NIOSH Response to SC&A Review of Savannah River Site Plutonium Construction Trade Worker Stratification Refinement White Paper

Response Paper

March 4, 2020

Figure 1. 1986 Regression coefficient fit plot showing the portion that was expanded by SC&A (see Figure 2).

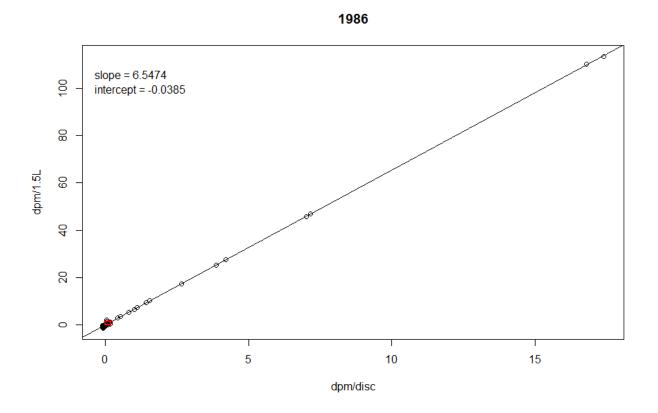
The use of a regression analysis to convert raw bioassay results (dpm/disc) to a volumetric result (dpm/1.5 L) has not been technically justified and does not appear scientifically defensible.

In the absence of a site-supplied formula to convert dpm/disc results to dpm/1.5L, logbook samples with both a dpm/disc and a dpm/1.5L result were plotted using yearly scatterplots. Because of what appear to be fairly strong linear relationships, NIOSH chose to use robust simple linear regressions to describe those yearly relationships. NIOSH acknowledges that the yearly linear relationships are not perfect, because all of the points do not fall exactly on the line. Some data deviate from a linear relationship due to (1) suspected miscalculations from the site, (2) transcription errors, (3) chelation from known intakes, (4) variable recovery factors, and (5) different aliquot sizes. Recognizing that a volume correction may improve these yearly regressions, the use of the robust simple linear regression technique results in the fitted line following the trend of the majority of the data and the volume correction would not have much of an effect. This includes the 1980 plot that SC&A called "a particularly poor fit."

For example, Figure 1 represents the 1986 regression line from Figure A5 in the original white paper [NIOSH/ORAUT 2019b].

Figure 2. Enlargement of 1986 regression coefficient fit plot.

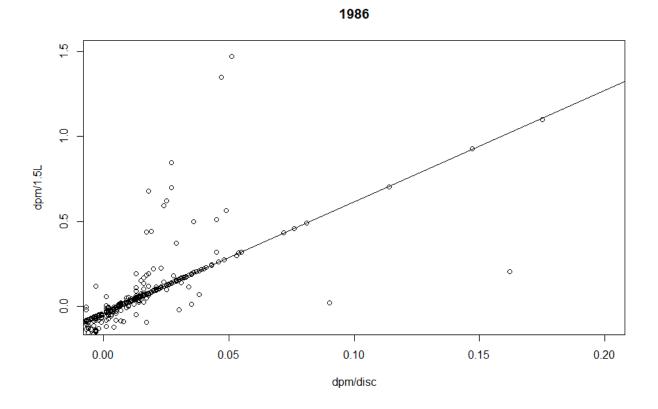
SC&A zoomed in on a portion of the x-axis to illustrate the variability associated with the linear fit at these very low concentrations. Figure 2 in this document replicates SC&A's Figure 5.

It is worth noting that the plot above contains negative values whereas SC&A Figure 5 did not include any negative values. There is one other difference between the plot above and SC&A's Figure 5. In the Incident/Exclusions section of the statistical analysis instructions on page 4 of NIOSH/ORAUT [2019b], the final bullet states that a worker was chelated in 1986. All of that worker's results in 1986 were within 100 days of chelation (actually within a month of chelation), so they were not included in any analysis, meaning they were not part of the 1986 regression. These chelated results are in SC&A's Figure 5. For ease of comparison, NIOSH took the plot above and added the chelated points in red. See Figure 3.
